AUBREY DAVIS PARK TRAIL SAFETY IMPROVEMENTS

REVISIONS TO 30% DESIGN PACKAGE

PARKS & RECREATION COMMISSION MEETING
JULY 7, 2022

Aubrey Davis Trail 30% Design Revisions

Examples of bike regulatory signage

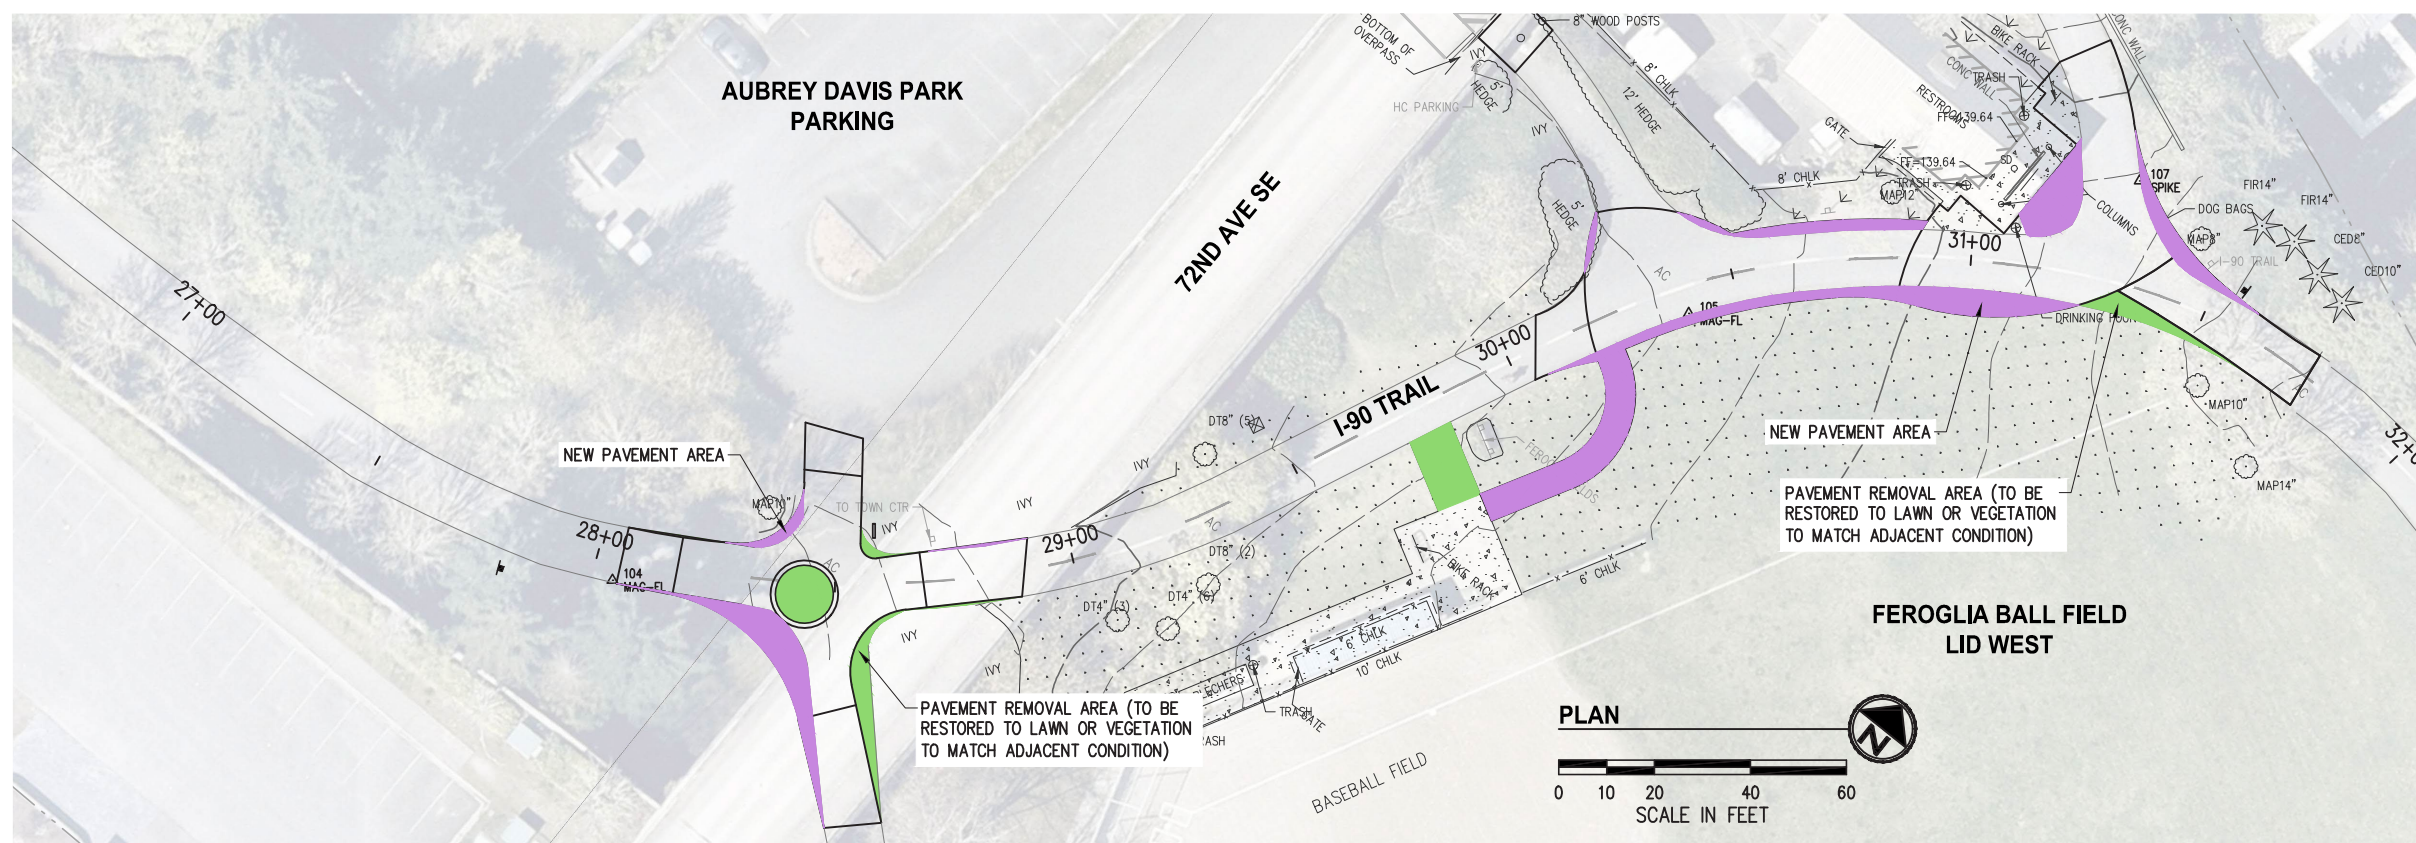
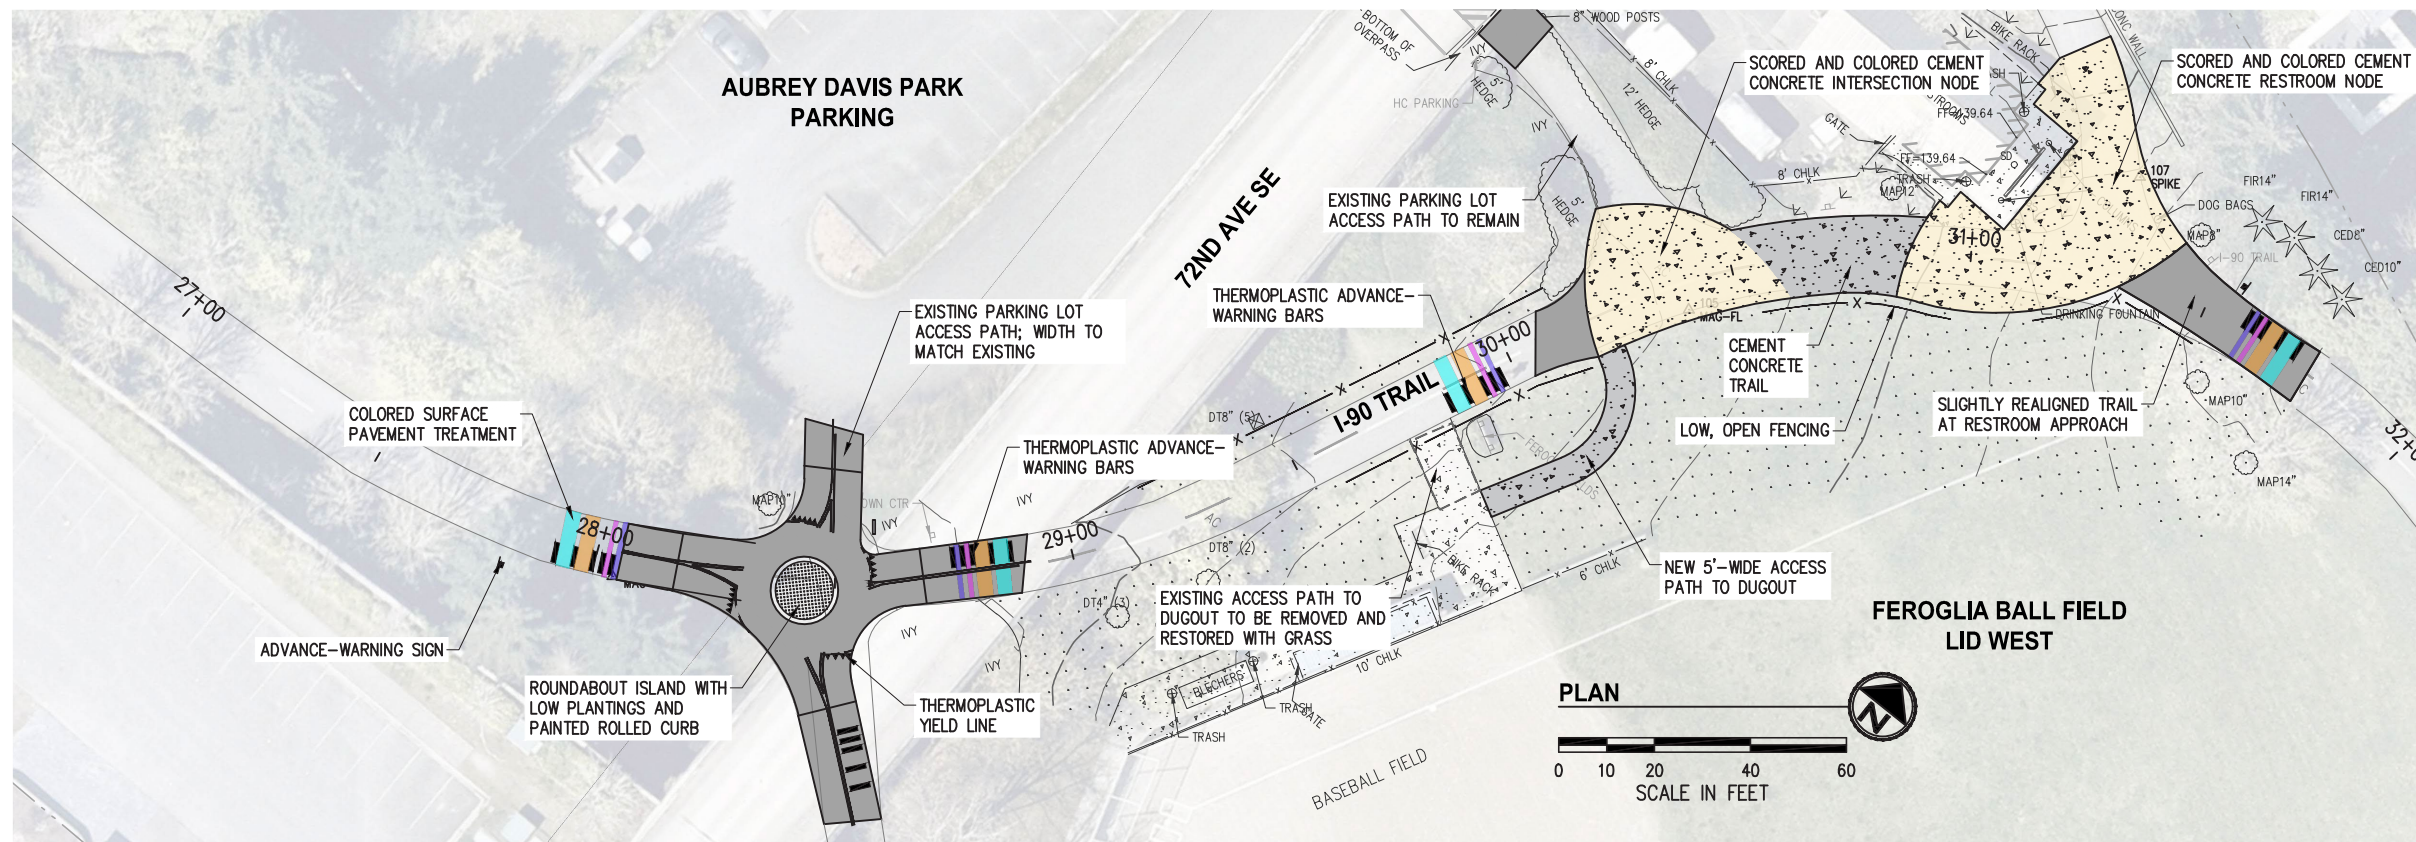
- Additional trail safety measures will be included, such as reflective paint and warning signage at the roundabout and on approaches, including:
 - Warning signage at the top of the hill/curve by the tennis courts as well as halfway down and just before the roundabout (for example, SLOW and YIELD AHEAD pavement markings and “caution blind curve”, “intersection ahead” and “yield” signage)

- Reflective sheeting on sign posts, reflective yellow paint on mountable curb, reflective yield markings and channelization at roundabout approaches.
